File number: AP-AV-03-0003

MODIFICATION ACCEPTANCE LETTER (MAL) FOR Approved Measuring Devices

Diesel / Gasoline Dispenser

AV-2372

Skinner Valves with Manifold

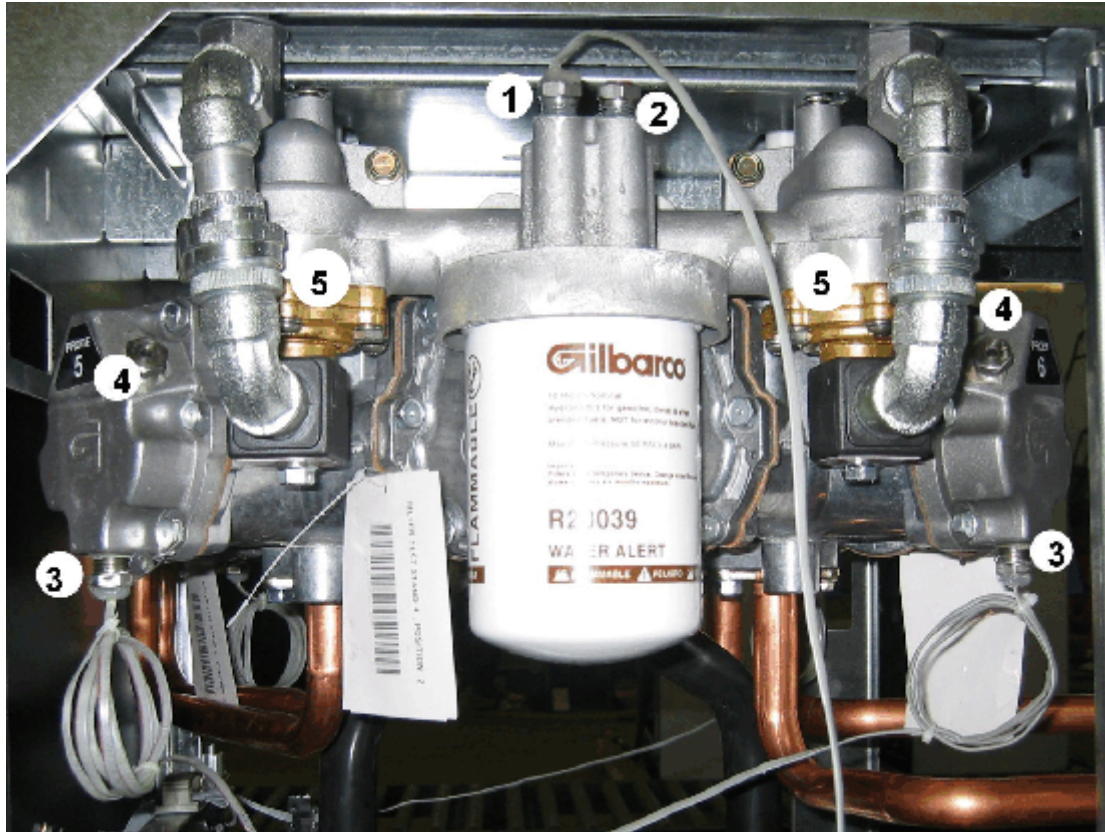
The inlet manifold and filter connected to the Skinner valves for the Encore 300 and 500 also includes a centrally located ATC probe and inspector thermowell. This single probe and thermowell now replaces the individual ATC probes and thermowells on the two meters on the manifold. The end covers on the meters are replaced with plain covers.

1. New ATC Probe
2. New Inspector Thermowell
3. Old ATC Probes
4. Old Inspector Thermowell
5. Skinner Valves

Soupages de Skinner avec tuyau

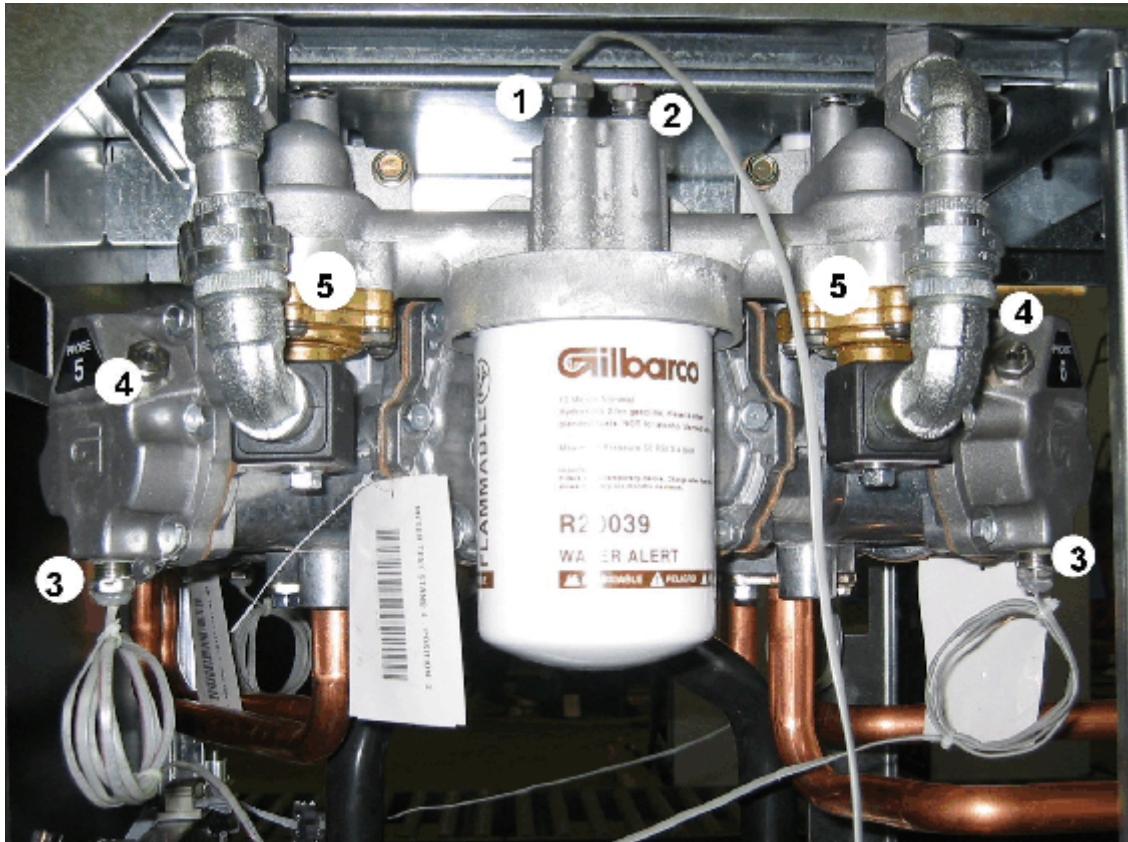
Le tubalure d'admission et filtre qui sont reliés aux soupapes de Skinners pour le Encore 300 et 500 incluent aussi une sonde de CTA de façon centralisée localisés et thermowell d'inspecteur. Cette sonde seul et thermowell remplacent maintenant les sondes de CTA individuelles et thermowells sur les deux compteurs sur le tubalure d'admission. La bout couvertures sur les compteurs sont remplacé avec les couvertures ordinaires.

1. Nouveau ATC Sonde
2. Nouveau Thermowell d'Inspecteur
3. Vieux ATC Sonde
4. Vieux Thermowell d'Inspecteur
5. Soupapes de Skinner
